## Economic Commission for Europe

**Tyres: UN Regulation No. 117 (Tyre rolling resistance, rolling noise and wet grip)**

## **Proposal for Supplement 2 to the 04 series of amendments to UN Regulation No. 117**

### **Submitted by the experts from the European Tyre and Rim Technical Organization\***

Figure 1  
**Nomenclature explanation related to grip index of the tyre**

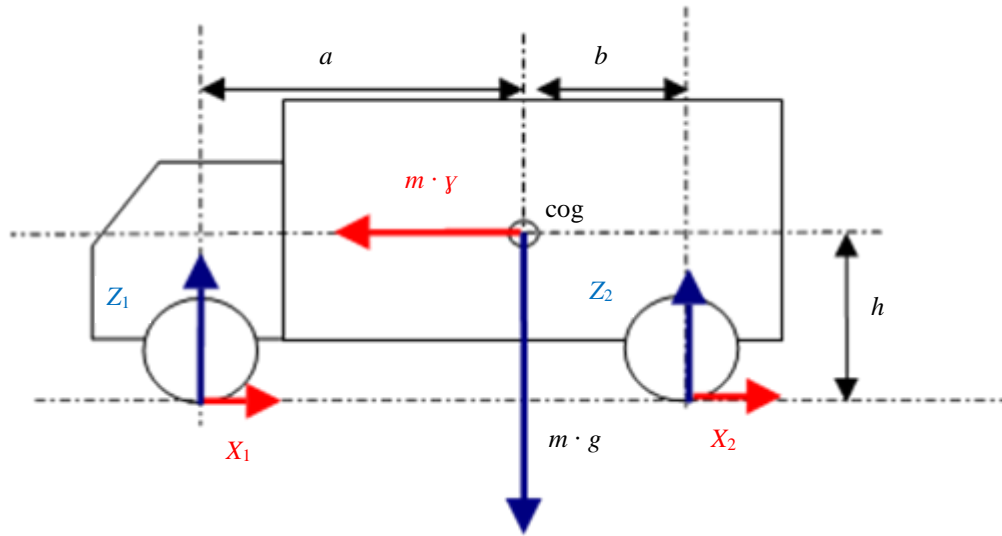
Paragraph 2.2.2.7.5., amend to read:

The wet grip index represents the relative performance of the candidate tyre compared to the reference tyre. The way to obtain it depends on the test configuration as defined in paragraph 2.2.2.2. of this Annex. The wet grip index  $G$  of the tyre is calculated as reported into Table 7:

Configuration C1: candidate tyres on both axles	$G = f \cdot \frac{BFC(T)}{BFC(R)}$
Configuration C2: candidate tyres on front axle and reference tyres on rear axle	$G = f \cdot \frac{BFC(T) \cdot [a + b + h \cdot BFC(R)] - a \cdot BFC(R)}{BFC(R) \cdot [b + h \cdot BFC(T)]}$
Configuration C3: reference tyres on front axle and candidate tyres on rear axle	$G = f \cdot \frac{BFC(T) \cdot [-a - b + h \cdot BFC(R)] + b \cdot BFC(R)}{BFC(R) \cdot [-a + h \cdot BFC(T)]}$

<i>For class C2 tyres</i>	
<i>SRTT16C</i>	
$f = 1$	
<i>For class C3 tyres</i>	
<i>SRTT19.5, SRTT22.5</i>	<i>SRTT19.5 siped, SRTT22.5 siped</i>
$f = 1$	$f = 1.04$

**$f$ :** correction factor depending on used SRTT
